HISTORIC AND DESIGN REVIEW COMMISSION

HDRC CASE NO: 2016-514
ADDRESS: 919 LAMAR ST
LEGAL DESCRIPTION: NCB 1369 BLK 6 LOT S 127.5 FT OF 13
ZONING: R-4 CD,H
CITY COUNCIL DIST.: 2
DISTRICT: Dignowity Hill Historic District
APPLICANT: Yussy El-Hibri/Y Designs, LLC
OWNER: Yussy El-Hibri/Y Designs, LLC
TYPE OF WORK: Construction of a rear addition, front porch modifications, fencing and exterior modifications

**Historic and Design Review Commission
Design Review Committee
Report & Recommendation**

ROOF / SITE PLAN

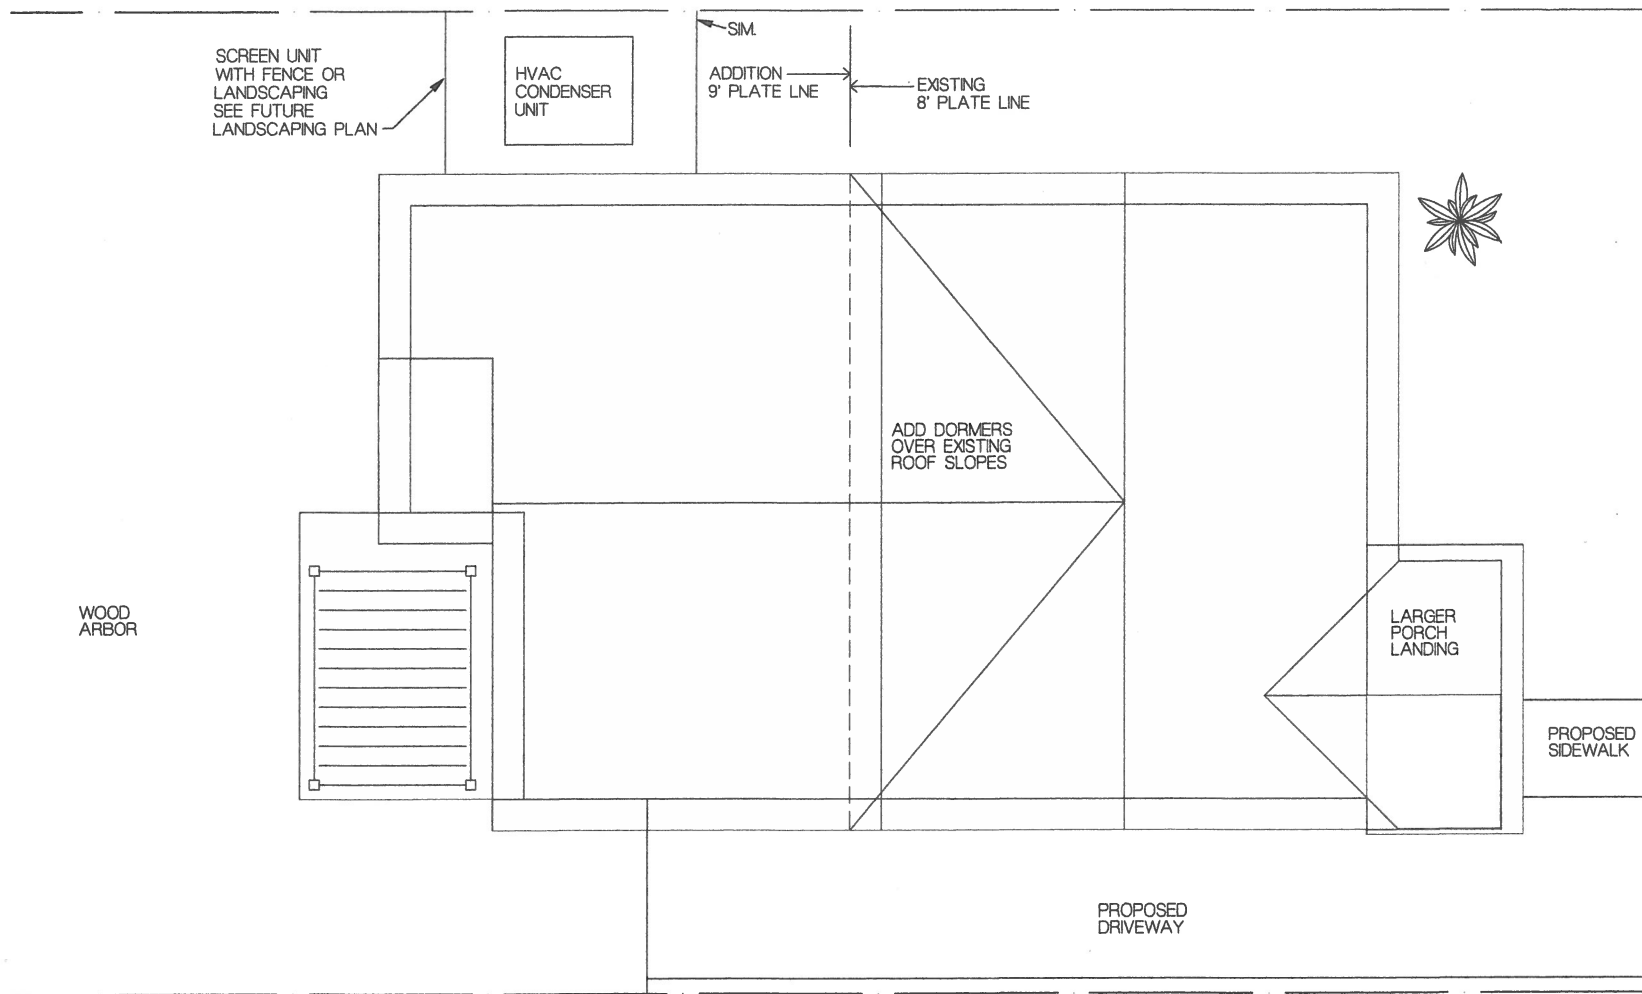
COMMENTS/CONCERNS: MG! QUESTIONS REGARDING THE PROPOSED
NEW ROOF HEIGHT/MASSING. HOW HAS THE PROPOSED ROOF PITCH
CHANGED? -CURRENT MODIFICATIONS HAVE APPROPRIATE CHANGES.

THE PROPOSED PARKING LOCATION IS APPROPRIATE REGARDING
EXISTING SITE LOCATIONS. JL! A LANDSCAPING PLAN SHOULD BE
~~PROVIDED~~ PROVIDED AT A LATER DATE NOTING ALL MATERIALS.

MG! THE SITE PLAN SHOULD INCLUDE ALL SITE ELEMENTS. HVAC
UNITS SHOULD BE SCREENED; LANDSCAPING OR A SMALL FENCE

SITE LINE DIAGRAM

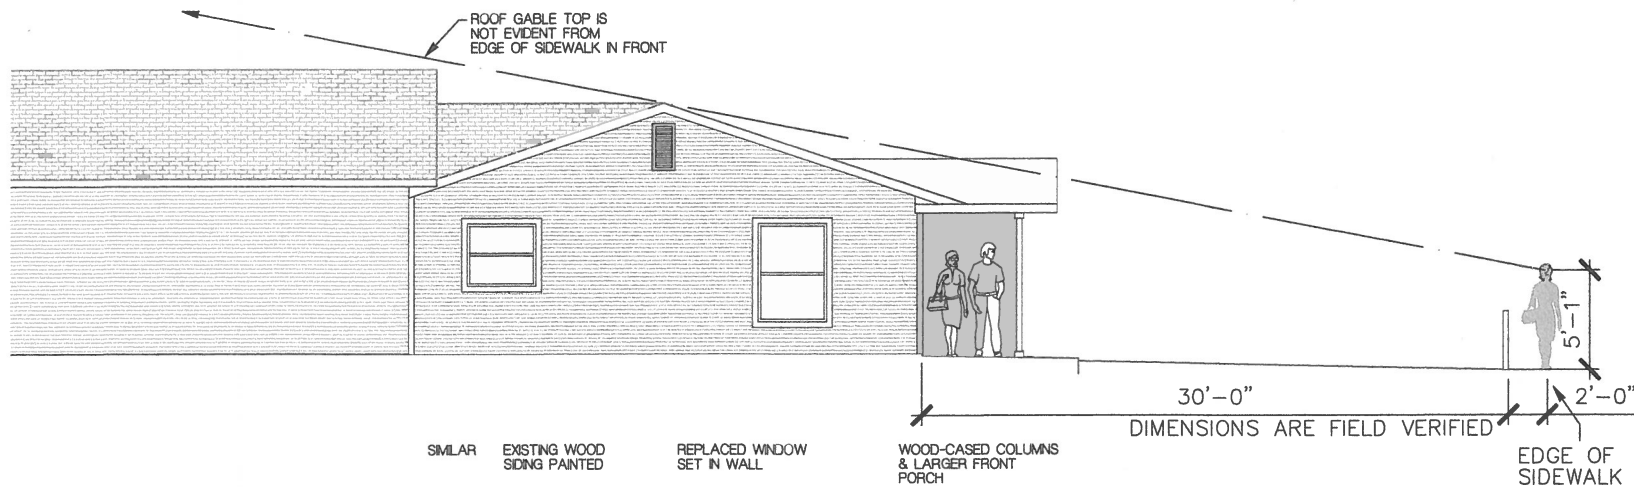
- i. ADDITION – At the rear of the primary historic structure, the applicant has proposed to construct an addition featuring a footprint of approximately 620 square feet. The Guidelines for Additions 1.A. states that additions should be sited to minimize visual impact from the public right of way, should be designed to be in keeping with the historic context of the block, should utilize a similar roof form and should feature a transition between the old and the new. The applicant has proposed to construct the addition in a manner where the addition would feature a ridge height that exceeds that of the primary structure and a proposed massing. The applicant has provided a line of sight study that notes the proposed addition's height will not be seen from the public right of way.

- j. SCALE, MASS & FORM – As noted in finding i, the massing and form of the rear addition should be subordinate to that of the primary structure. The applicant has proposed an overall scale that is comparable to the primary historic structure; however, the height of the addition's ridge line is greater than that of the primary structure. The applicant has provided a line of sight study which notes that the addition's height will not be seen from the public right of way at Lamar. Staff finds that given the construction period of the primary structure as well as the primary's structure's overall height, which is significantly shorter than heights of neighboring historic structure, that the proposed addition's height is appropriate.

REAR TO FRONT SECTION

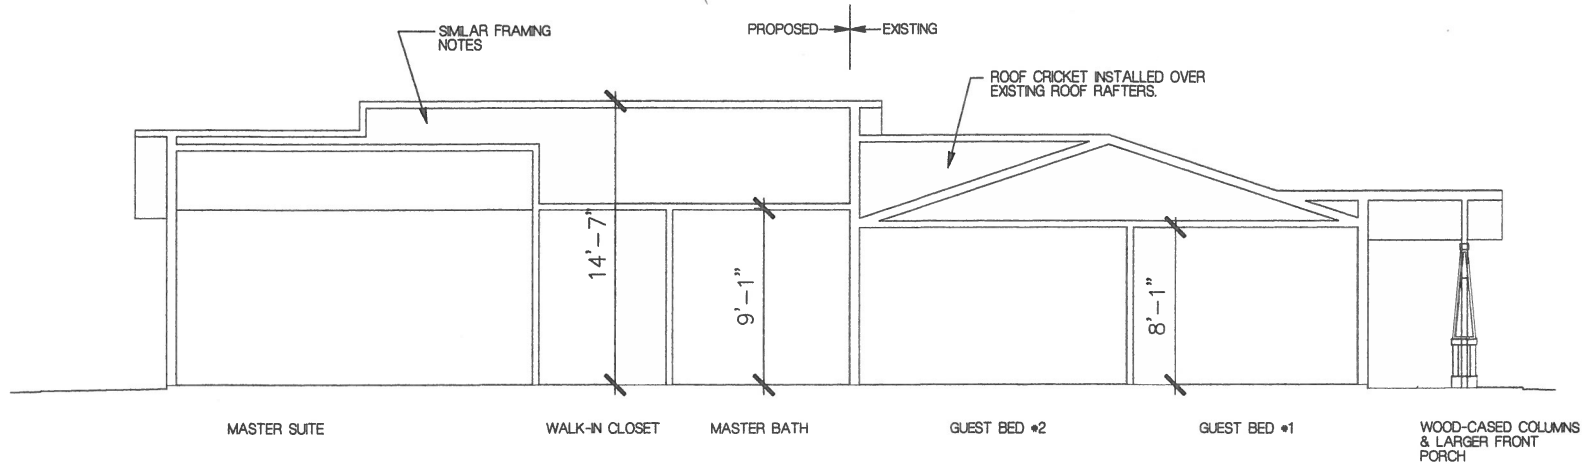
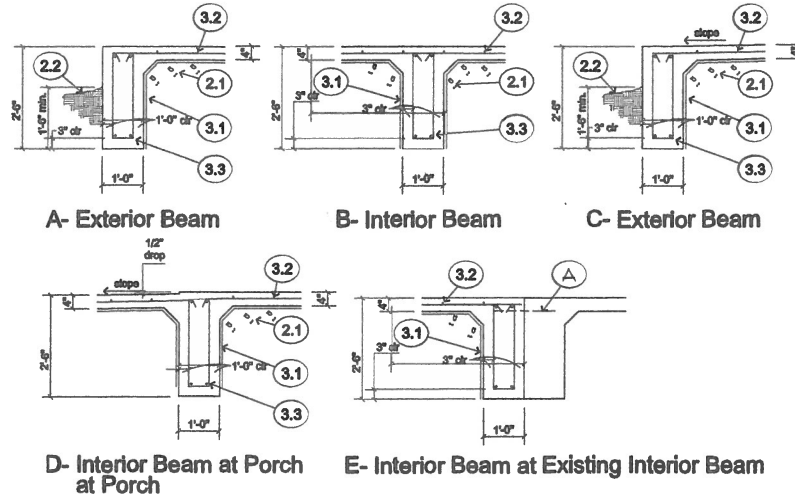
ADJUSTED FOR LOWER PLATE LINE
